**HISTORIC PRESERVATION COMMISSION
REGULAR MEETING
NOVEMBER 19, 2020
ASSEMBLY HALL
395 MAGNOLIA ROAD
PINEHURST, NORTH CAROLINA
4:00 PM**

FINAL ORDER – MAJOR COA REQUEST 105 Fields Road
VILLAGE OF PINEHURST
HISTORIC PRESERVATION COMMISSION

To: Historic Preservation Commission
From: Peter Hughes, Senior Planner
CC: Darryn Burich, Planning and Inspections Director
Kelly Brown, Administrative Specialist
Date: December 9, 2020
Subject: Major COA Request for 105 Fields Road

To: Historic Preservation Commission
From: Peter Hughes, Senior Planner
CC: Darryn Burich, Planning and Inspections Director
Kelly Brown, Administrative Specialist
Date: December 7, 2020
Subject: Major COA Request for 30 Everett Road

ELEVATION DRAWING

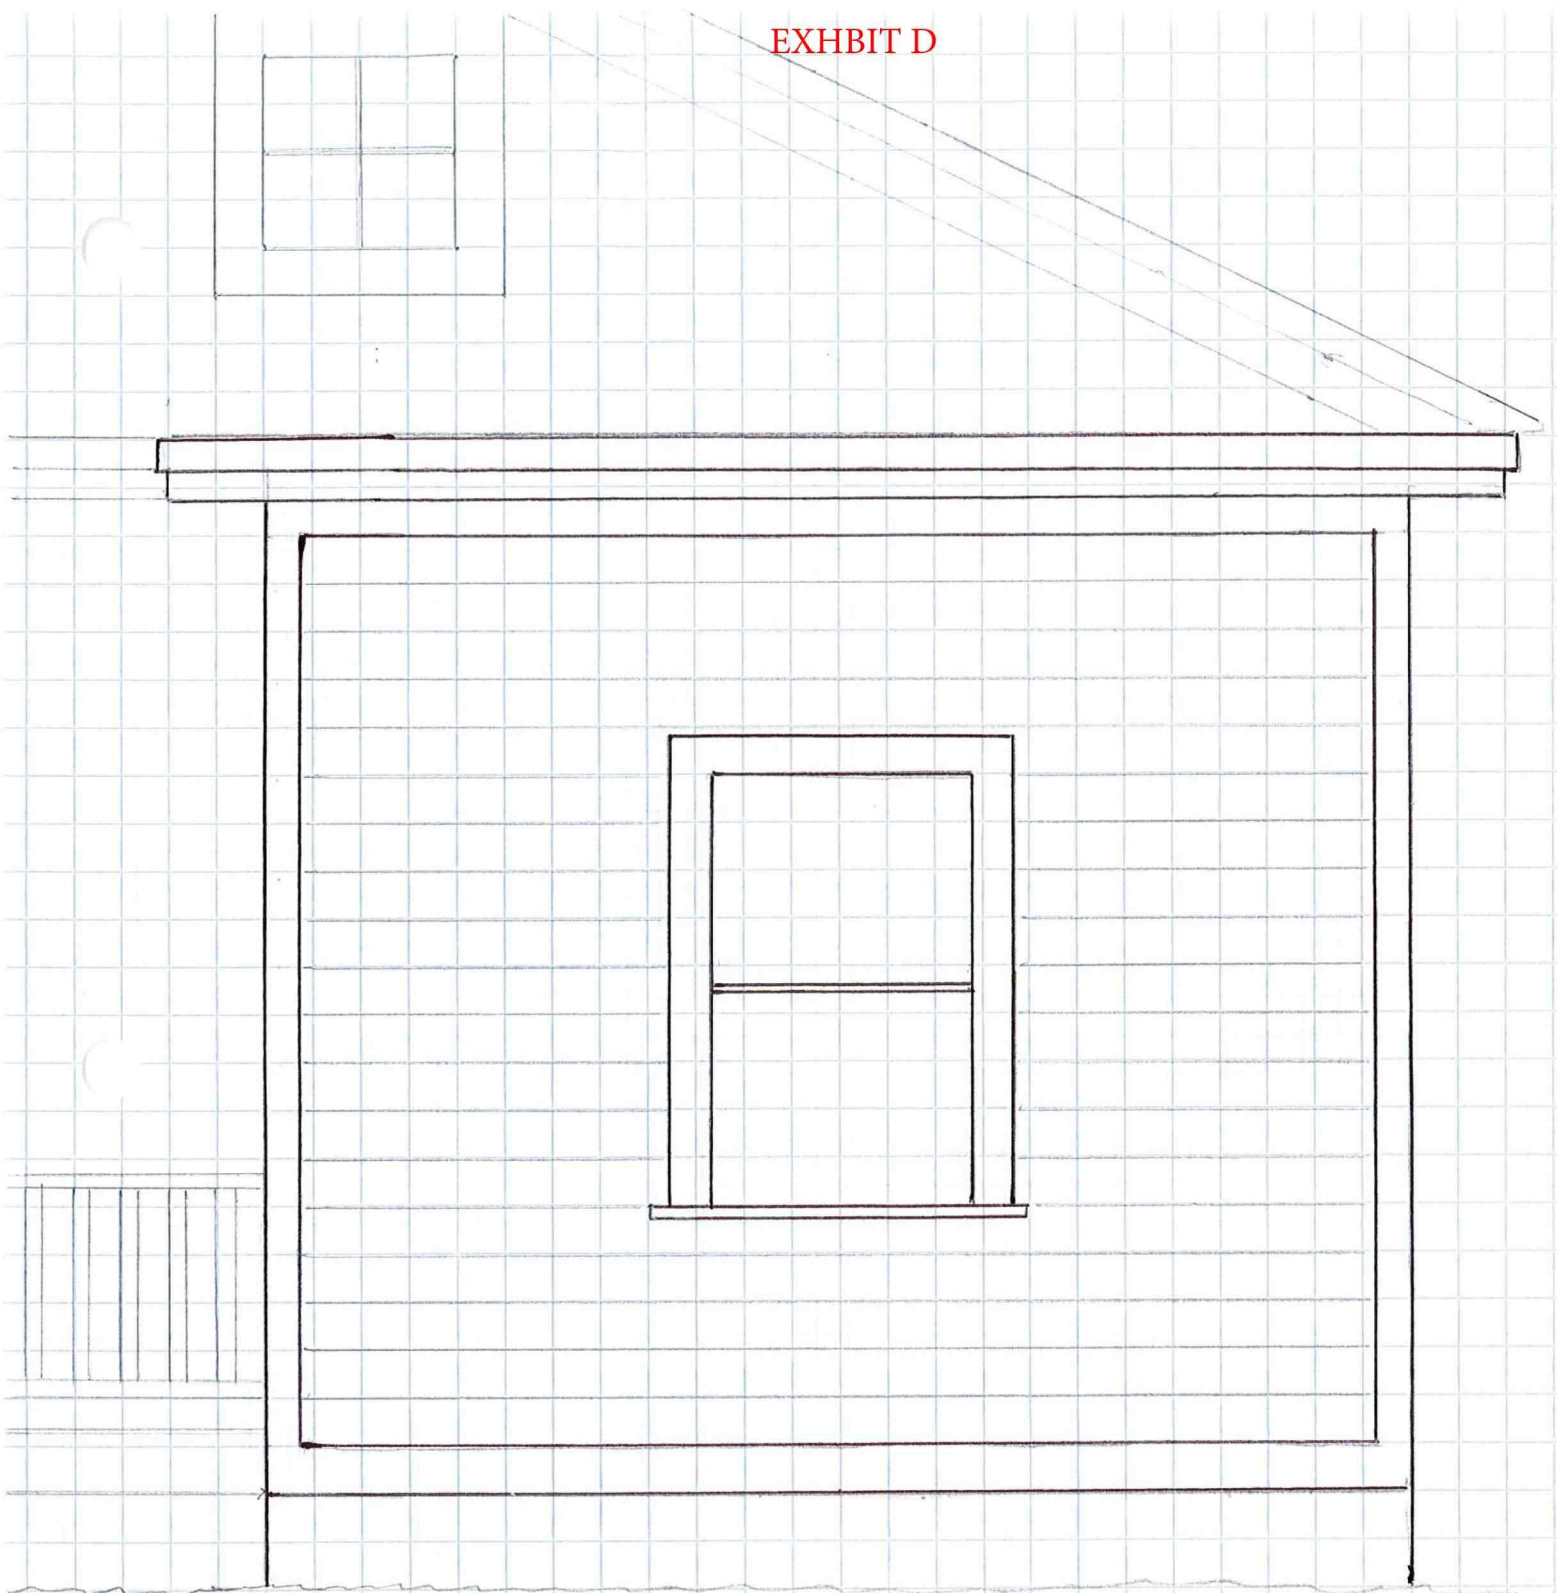
The bow window is incongruous with the historic origins of the Retreat cottage/bungalow. The bow window probably was added in or around the 1950's or 1960's as part of an addition to Retreat. The bow window is more compatible with suburban ranch house styles of that time, not cottages such as Retreat built in 1895. I can not find a bow window on any other historic cottage in the Pinehurst Historic District.

As mentioned above, the applicant is requesting to replace a 108"x53" bow window with a 32"x53" double hung window. The existing bow window is the only window of its style featured on the house and it is not visible from street as it is (located on the right elevation).

The reduction in window area from a bow to double hung window will require the addition of siding material. The applicant has proposed to match the existing wood, lap siding like for like. Lap siding is an architectural detail featured throughout the Historic District.
